1990 Corvette: Service Bulletin: Clutch Apply Plate Material Changed to Powdered Metal

Subject: CLUTCH APPLY PLATE MATERIAL CHANGED TO POWDERED METAL
Model and Year: 1990 ALL CARS, TRUCKS, VANS WITH 4L60 (700-R4) AUTOMATIC TRANSMISSION
Source: Chevrolet Service Bulletin
Bulletin Number: 90-189-7A - (03/06/1990)

Figure 1 - THM 700-R4/HYDRA-MATIC 4L60 Transmission Identification Information

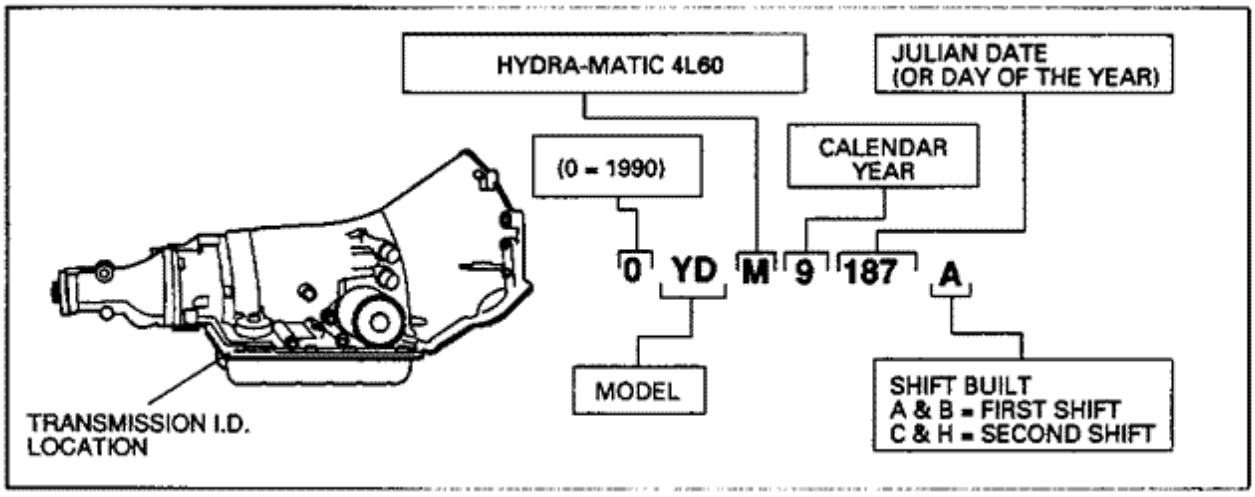
This bulletin covers a material change for the forward and 3-4 clutch apply plates. These clutches will now contain apply plates manufactured from powdered metal instead of steel.

The following dates show when changes went into effect: (Figure 1)

Forward January 25, 1990 (Julian Date 025)

3-4 January 29, 1990 (Julian Date 029)

Figure 2 - 3/4 And Forward Clutch Apply Plates

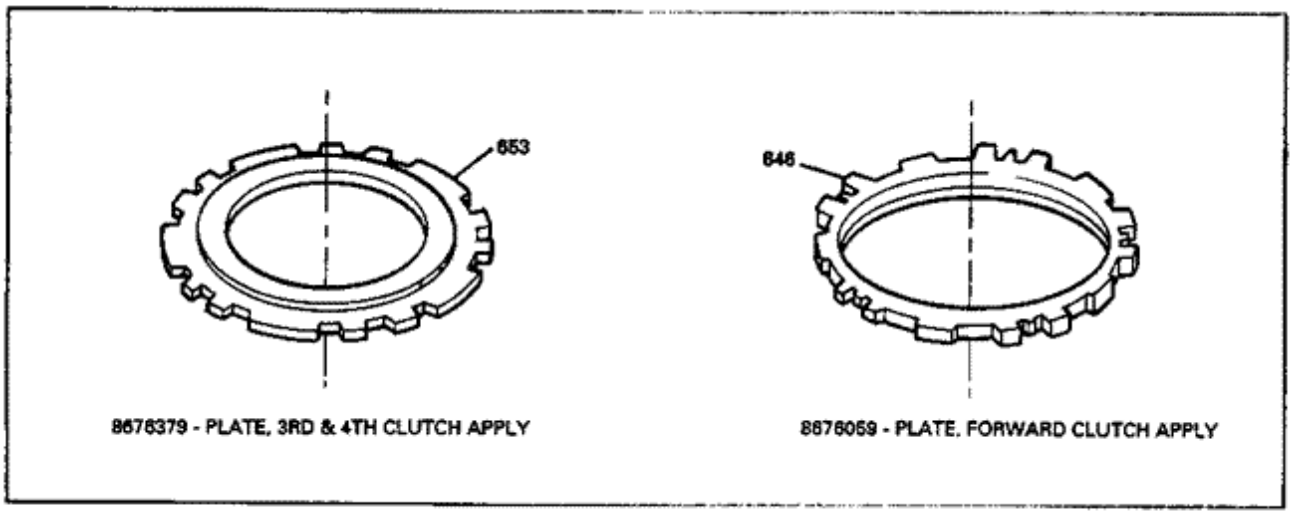
The new powdered metal plates are interchangeable with the current steel plates. Dimensions of the new powdered metal plates are the same as the steel plates. Powdered metal plates will appear darker in color than previously produced steel plates.

Part numbers have changed. (Figure 2)

8676059 Apply Plate - Forward Clutch (powdered metal)

8676379 Apply Plate - 3-4 Clutch (powdered metal)

When GMSPO stock of steel plates is used up, powdered metal plates will be available for service.
